Service Bulletin

Service Bulletin No. 068

Jasco Alternator Wire Harness Wire Chafing Protection or Replacement

Figure 1 - Wire Harness Chafing Condition

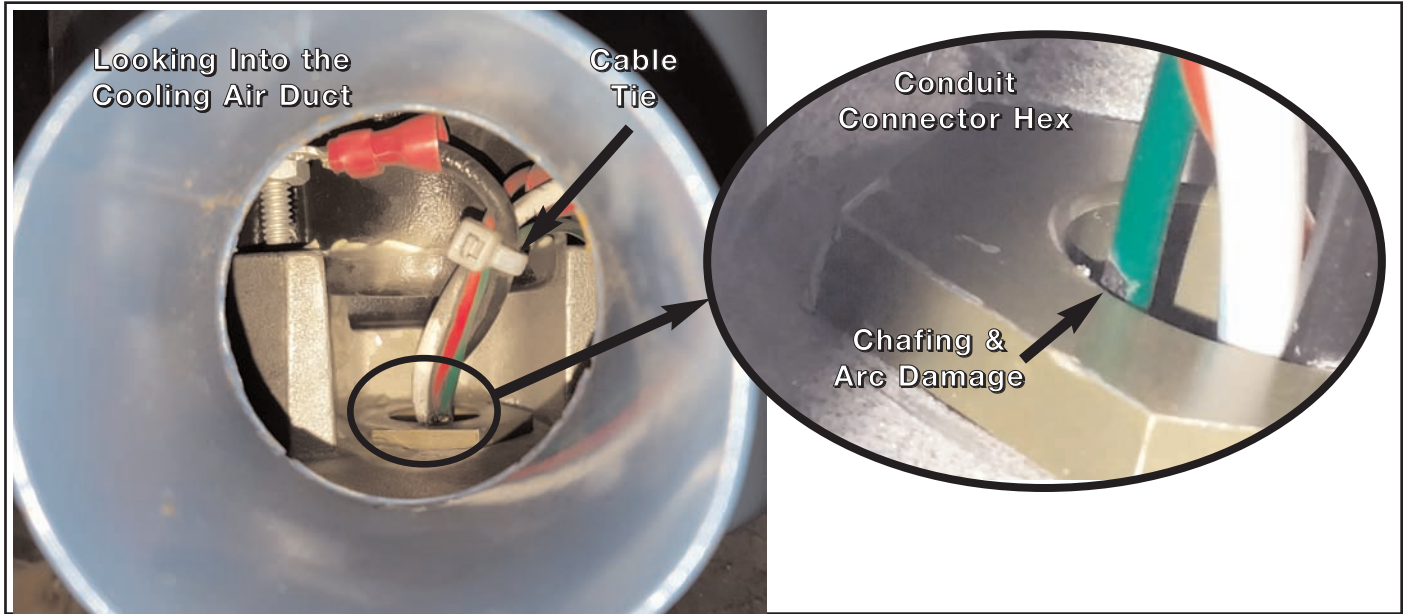
- (1) All Jasco alternator models with serial numbers per the Effectivity above may experience a chafing condition of the electrical harness during normal operation.
- (2) A chafing condition of the electrical harness may result in electrical arcing, tripped circuit breaker, and loss of alternator function. Refer to Fig. 1.
- (3) Regulatory action is unknown.

- (a) Tighten the spiral insulation wrap to limit any gaps. Refer to Fig. 1 and Fig. 3.
 - (11) Push the knurl collar with retained grommet along the wire harness to the conduit connector.

- (i) Torque the HET P/N 41070 screws to 25-35 in-lbs (2.83-3.95 nm).
- (19) Install a cable tie to secure the wire harness at the base of the conduit connector shown in Fig. 1.

Figure 2 - Component Identification

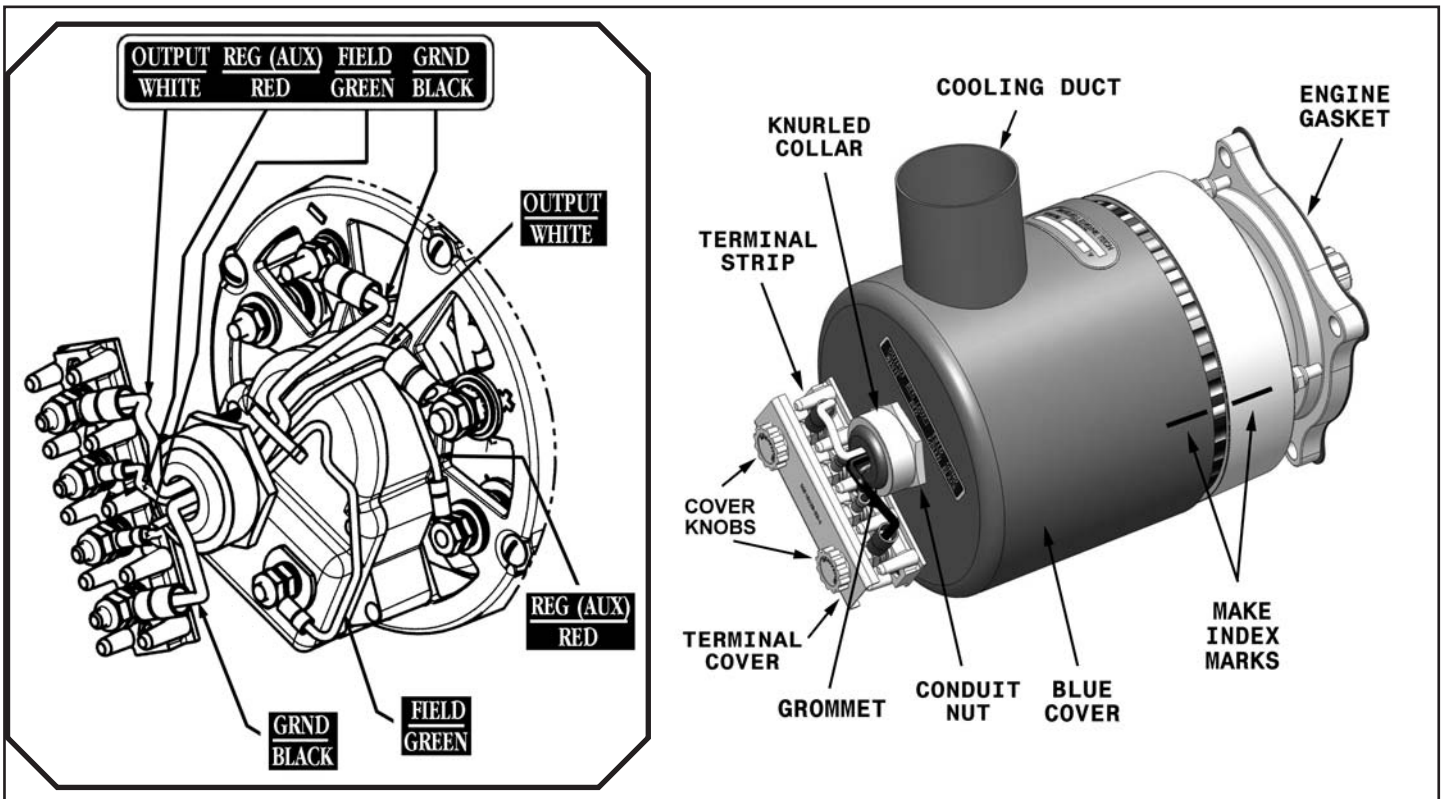
- (1) The addition of chafing protection may be performed with the alternator mounted to the engine.
- (2) Disconnect aircraft battery and other sources of electrical power.
- (3) Loosen the terminal strip protective cover knobs and remove the cover. Refer to Fig. 2.
- (4) Remove and discard the four nylon insert lock nuts from the terminal strip wire studs.
- (5) Remove the four AIRCRAFT wires from their studs.
 - (a) Insulate and tag each wire function.
- (6) Remove and retain the four 10-24 jam nuts and washers from the terminal strip wire studs.
- (7) Remove the four color coded wires from the terminal studs and pull them straight.

- (12) Thread the knurl collar onto the conduit connector.
 - (a) Tighten the knurl collar finger tight then 1/4 turn more. Refer to Fig. 4.
 - (13) Install each wire on the terminal strip stud that corresponds to the color of the wire and the color listed on the placard above the terminal strip. Refer to Fig. 2.

- (a) Put the retained flat washer and jam nut on the terminal strip stud.
 - (b) Torque each AN315-3R jam nut to 30-40 in-lbs (3.39-4.52 nm).
 - (14) Install each AIRCRAFT wire on the terminal strip stud that corresponds to the function of the wire as marked and as listed on the placard above the terminal strip. Refer to Fig. 2.

- (2) Disconnect aircraft battery and other sources of electrical power.
 - (3) Loosen the terminal strip protective cover knobs and remove the cover. Refer to Fig. 2.

- (8) Put an index mark on the blue cover extending onto the drive end housing. Refer to Fig. 2.
 - (9) Using a soft jaw connector plier, loosen the knurl collar completely. Refer to Fig. 4.

- (10) Pull and remove the knurl collar with retained grommet from the conduit connector. This allows removal of the blue alternator cover to expose the other end of the wire harness. Refer to Fig. 2.

- (12) Using a spanner wrench, loosen and remove the conduit connector nut. Refer to Fig. 4.
- (13) Remove the blue alternator cover to expose the wire harness connections. Refer to Fig. 2.

- (a) Cut the small cable tie that secures the wire harness. Refer to Fig. 2.
- (14) With the rectifier plate exposed, locate the white power wire and remove the 1/4 inch jam nut and lock washer.

- (20) With the new wire harness extending through the conduit connector, put the blue cover onto the alternator assembly and align it with the index mark applied in step 3.C(8). Refer to Fig. 2.

- (a) Put the retained flat washers and jam nuts on the terminal strip studs.
 - (b) Torque each AN315-3R jam nut to 30-40 in-lbs (3.39-4.52 nm).
- (26) Install each AIRCRAFT wire on the terminal strip stud corresponding to the function of the wire as marked and as listed on the placard above the terminal strip. Refer to Fig. 2.

Figure 3 - Spiral Insulation Example

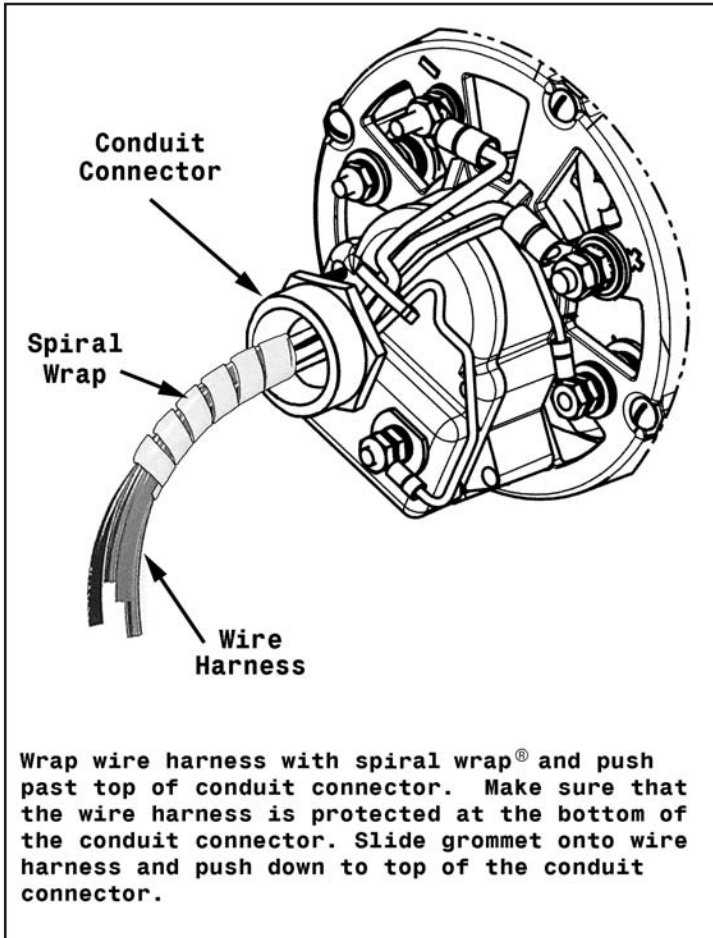
- (a) The chafing protection is a two inch piece of .375 inch PTFE spiral insulation that must be wrapped around all four wires of the wire harness. Refer to Fig. 3.

Figure 4 - Soft Jaw Connector Plier & Connector Stack Up

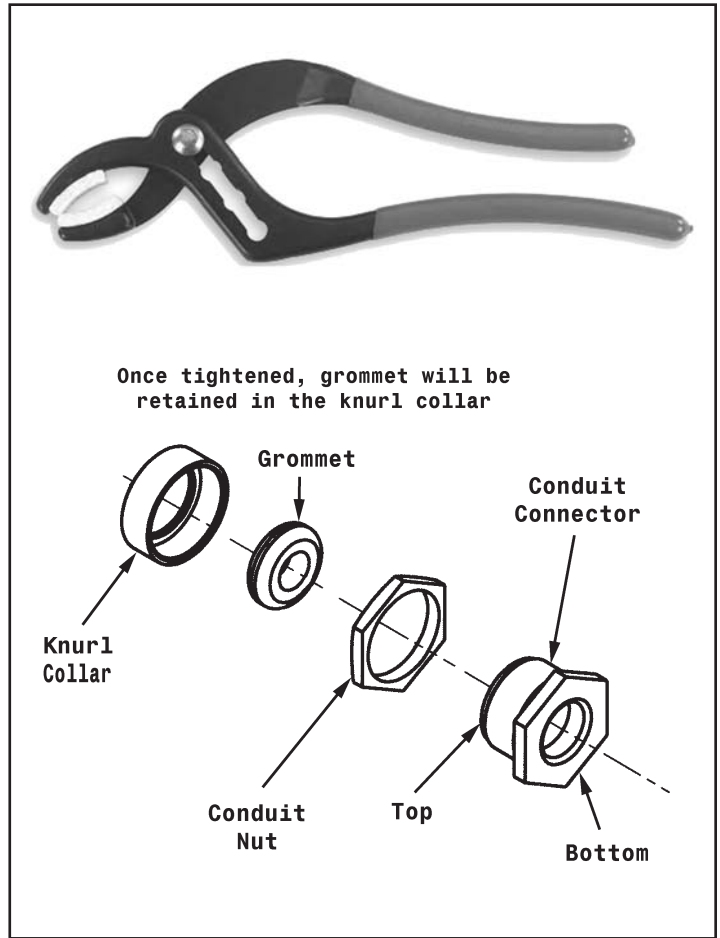
- (8) Using a soft jaw connector plier, loosen the knurl collar completely. Refer to Fig. 4.
 - (9) Move the knurl collar with retained grommet away from the conduit connector down the wire harness to allow room to install the chafing protection. Refer to Fig. 2 and Fig. 3.

- (24) Put the knurl collar with the retained grommet onto the conduit connector threads.
 - (a) Tighten the knurl collar finger tight then 1/4 turn more. Refer to Fig. 4.

Figure 5 - Machine Support Removal

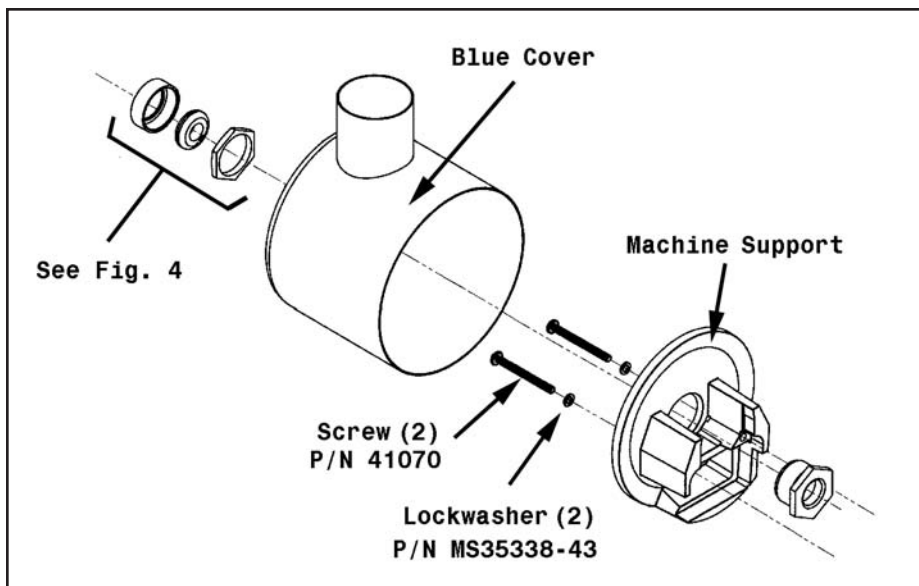
- (a) Thread the green AUX wire through the conduit connector and connect it to the stud.
 - (b) If torque of the green AUX wire nut cannot be achieved, it is permissible to remove the machine support by removing the two HET P/N 41070 screws and lockwashers. Refer to Fig. 5.

- (c) Torque the #10-24 inch jam nut to 30-40 in-lbs (3.39-4.52 nm).
 - (d) If removed, reinstall the machine support using the existing screws with new lockwashers P/N MS35338-43.
